ENGINEERING EVALUATION/COST ANALYSIS (EE/CA) REPORT FOR SITE LF01

Operable Unit 1,
Bellows Air Force Station, Oahu, Hawaii

**Review Comments and Responses
on the Draft EE/CA Report for Site LF01**

Figure 13
**Limited Surface Soil Excavation / Disposal
 with LTM of Groundwater (Alternative 4)**

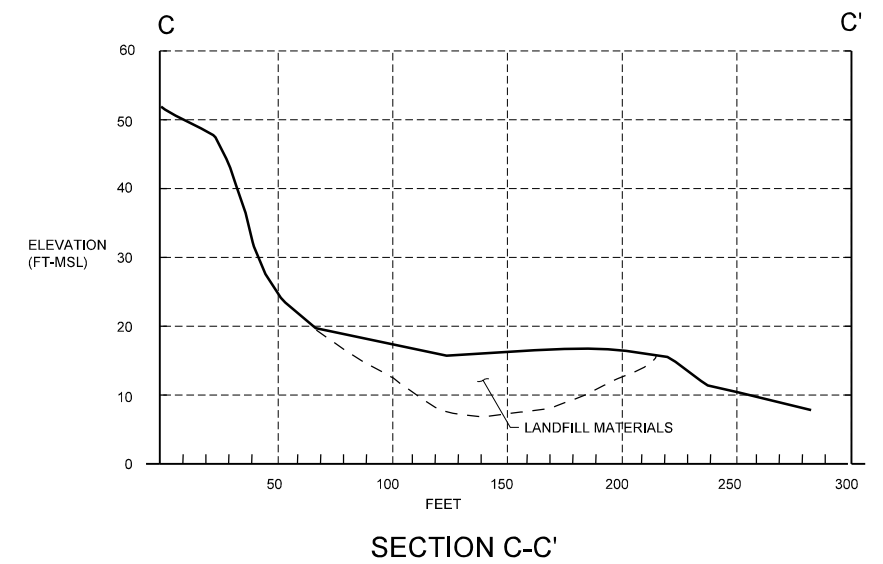
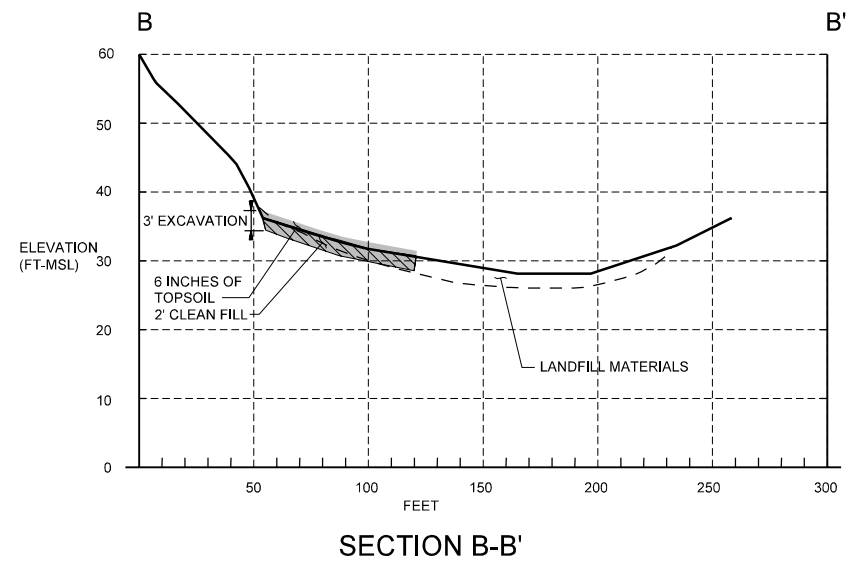
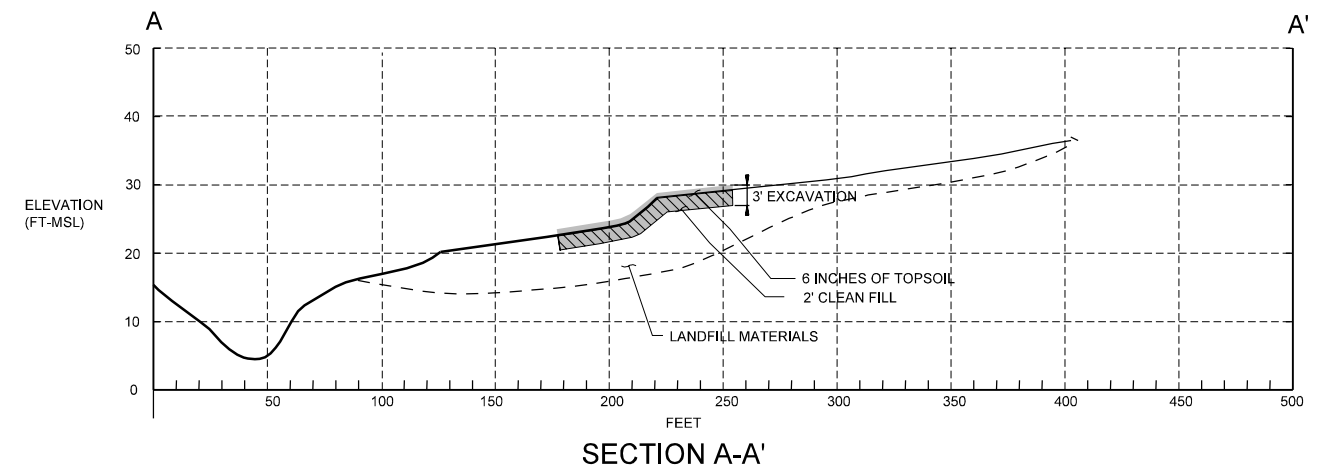
ITEM	PAGE	SECTION	COMMENT	CONTRACTOR RESPONSE
1		Alternative 4	How did the contractor arrive at the volume of 1,600 cubic yards of excavated soil?	This volume is based on the area depicted in Figure 13, calculated as approximately 13,800 square feet (where concentrations of lead exceeded the industrial PRG of 750 ppm) x 3-foot excavation = 41,400 cubic feet/27 cubic feet per cubic yard = 1,600 cubic yards (rounded up to the nearest 100 cubic yards).
2		Alternative 4	Why excavate to a depth of 3 feet?	Sampling during the EE/CA was from 0 to 2 feet; 0 to 3 feet was assumed for conservatism.
3		Alternative 4	What bulk density was used?	Bulk density was assumed to be 1.5 tons per cubic yard.
4		Alternative 4	How did the contractor arrive at the total of 2,400 tons?	1,600 cubic yards x 1.5 tons/cubic yard = 2,400 tons.
5		Alternative 4	What were the cover soil and top soil calculations based on?	Cover: It was assumed that 1/2 of the area would require cover (13,800/2 = 6,900 square feet x a 2-foot cover = 13,800 cubic feet/27 cubic feet per cubic yard = 520 cubic yards (rounded up to the nearest 10 cubic yards). Top soil: It was assumed that the entire area would require a top soil cover of 0.5 feet (13,800 square feet x 0.5 foot = 6,900 cubic feet/27 cubic feet per cubic yard = 260 cubic yards (rounded up to nearest 10 cubic yards).
